**TOWN OF BAY HARBOR ISLANDS
MORRIS N. BROAD COMMUNITY CENTER
1175 95TH STREET
BAY HARBOR ISLANDS, FL 33154**

DEVELOPMENT & REVIEW COMMITTEE MEETING

**TOWN OF BAY HARBOR ISLANDS
COMMUNITY DEVELOPMENT
MEMORANDUM**

Subject: Site Development Plan Application
1085 Townhouses – 6 DU Townhouse Complex
1085 94th Street
Bay Harbor Islands Acct. No. SPR24-000025
MMPA Account No. 01-0702-1197

DRAWING TITLE
LANDSCAPE PLAN

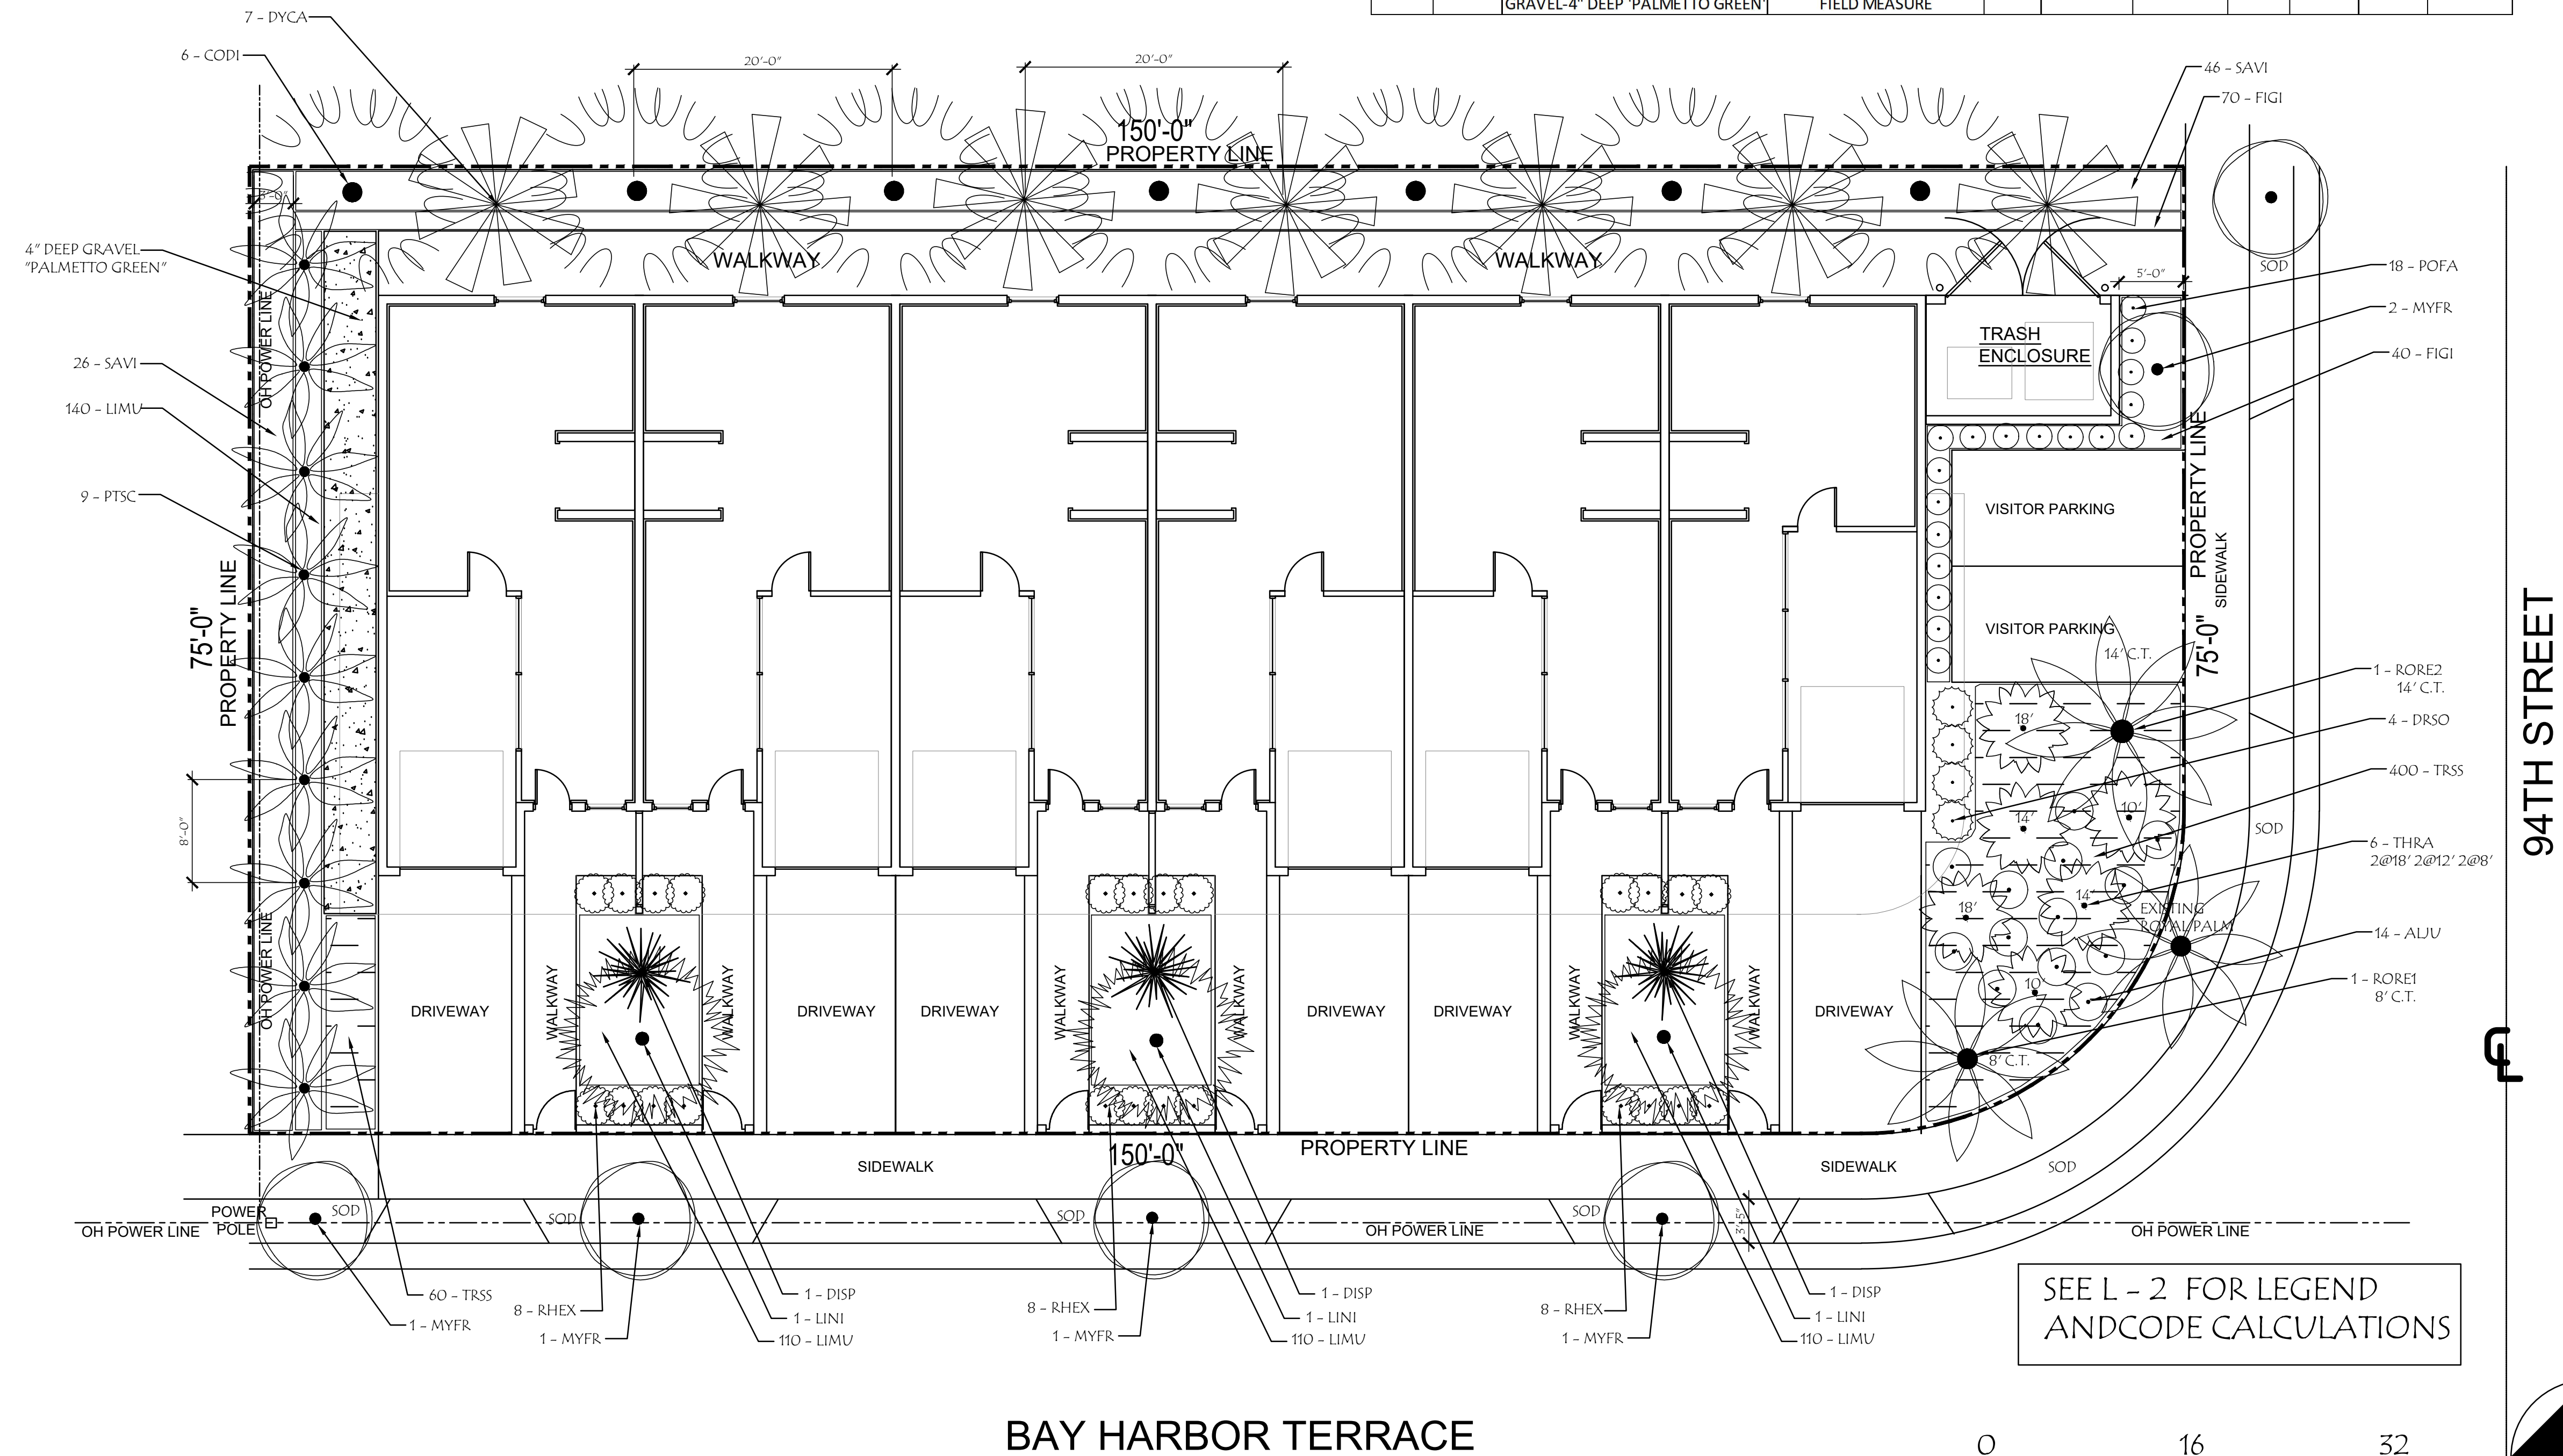
- 15) Landscape Plans – Sheet L-1 has the following issues:
 - **Street Trees** – Chapter 18B of the Miami-Dade Code is the countywide Street Tree Code. In addition, the Town has adopted its own Supplemental Landscape Code in Sec. 24-16 with higher standards than the county’s minimums. Finally, the Town has adopted a Master Street Plan with specified tree species per individual roadway segment. Sheet L-1 shows Simpson Stopper trees for Bay Harbor Terrace (correct due to OH wires) and no trees for Bay Harbor Terrace. The correct Street Tree for 94 Street is Mahogany. The required Street Tree sizes must be 15’ tall x 6’ clear trunk x 2.5” trunk caliper at time of planting spaced at 35’ on center. However, due to the OH wires on BHT the Town will allow shorter trees. Revise the Landscape Plan to include the correct required Street Tree species and sizes.

- **General Landscaping** - Chapter 18A of the Miami-Dade Code is the countywide Landscape Code. In addition, the Town has adopted its own Supplemental Landscape Code on Sec. 24-16 with higher standards than the county's minimum. A certain quantity and minimum size requirements for all lot trees / shrubs / grass / etc. is included. Sheet L-1 does not include the Town’s required Landscape Calculation Table demonstrating required / provided landscaping materials. See the attached table. Please revise the initial Landscape Plan to include the table / calculations and modify the plan as necessary to comply with minimum Code requirements. The Town uses the county's min. landscape quantity for multifamily developments (28 trees per acre). There are also native material / drought tolerant species requirements. Shade trees must be at least 12’ in height / 4’ spread / 2.5” caliper when planted. Palm trees must be at least 15’ tall when planted. A grouping of three (3) palm trees = one shade tree. Shrubs must be at least 24” tall / 24” on center when planted. Revise the Landscape Plan.
